# 1992 Corvette: Service Bulletin: Harsh 1-2 Upshift

**Subject:** HARSH 1-2 UPSHIFT INSTALL SERVICE PACKAGE

**Bulletin Number:** 92-318-7A - (09/15/1992)

**TRANSMISSION APPLICATIONS:** SUBJECT: 1992 HYDRA-MATIC 4L60 Harsh 1-2 Upshift ;Install Service Package

Figure 1 - HYDRA-MATIC 4L60 Transmission Identification Information

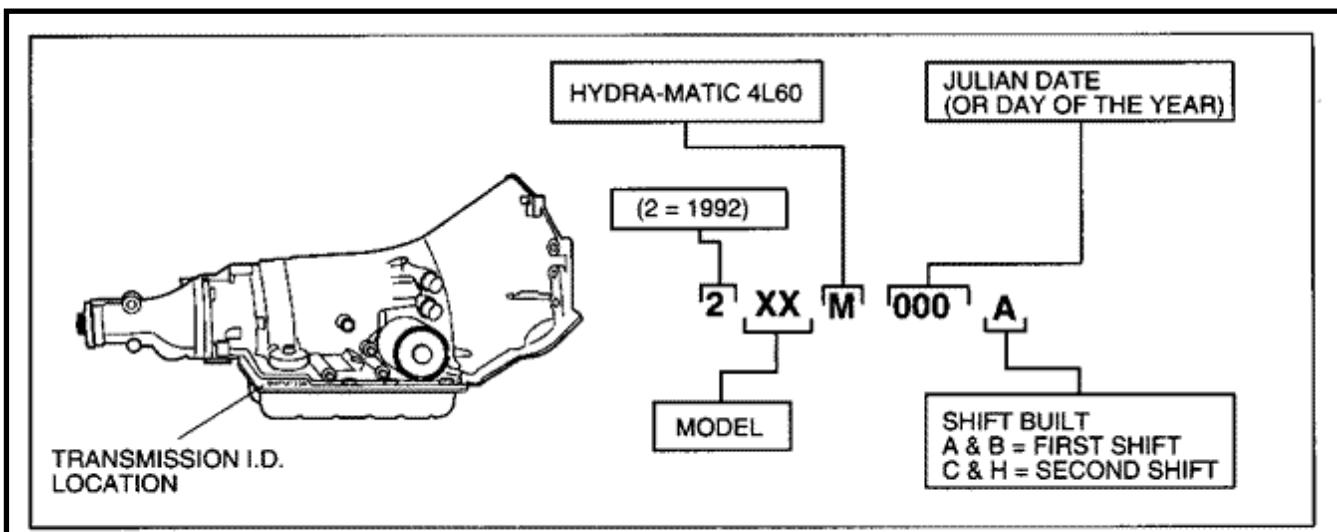
## **CONDITION (Figure 1):**

Some vehicles equipped with a 1992 HYDRA-MATIC 4L60 transmission built between Julian Date 061 (March 1, 1992) and Julian Date 171 (June 19, 1992) may experience a harsh 1-2 upshift. NOTE: Once the transmission is brought to operating temperature, the condition may not be able to be reproduced until a "cold soak" (overnight) is performed.

Figure 2

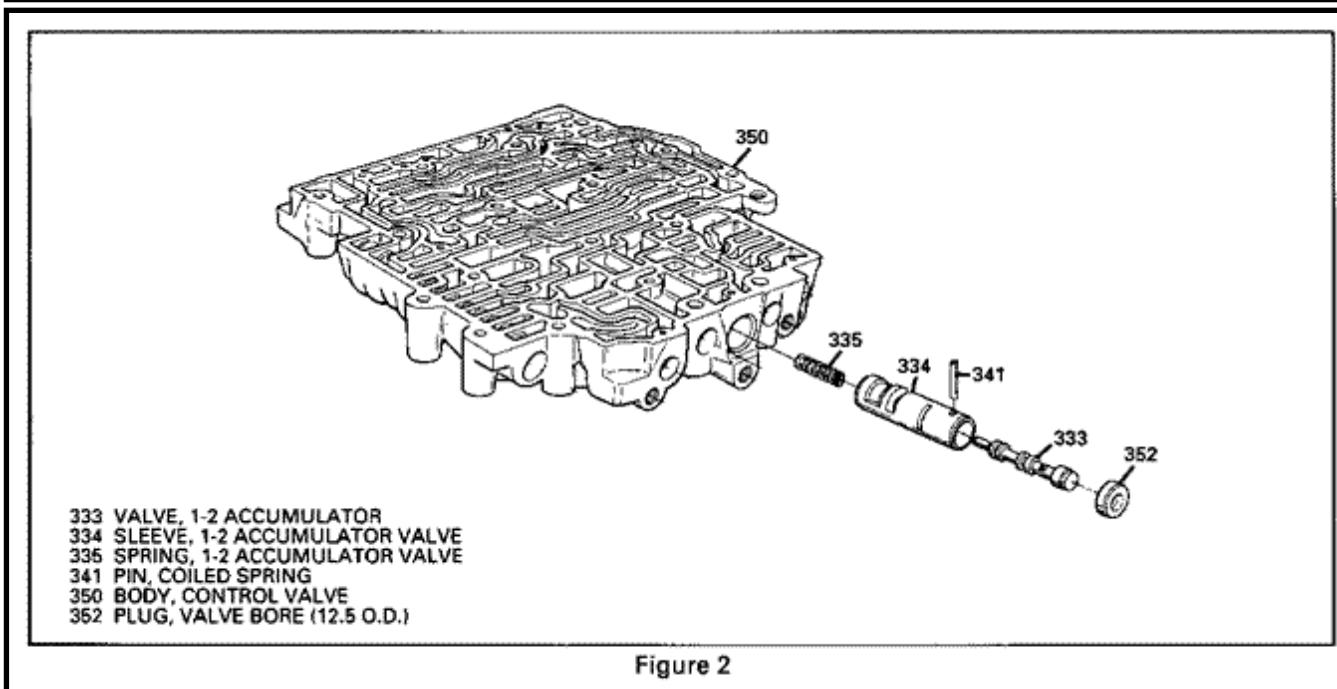
The above condition may be caused due to a tapered 1-2 accumulator sleeve. The tapered bore may cause the 1-2 accumulator valve to stick in the bottom of the bore.

## **CORRECTION (Figure 2):**

To improve the 1-2 shift, install the service package listed in this bulletin. A 1-2 accumulator valve and 1-2 accumulator valve sleeve (which, normally, is not serviceable) is included in the package.
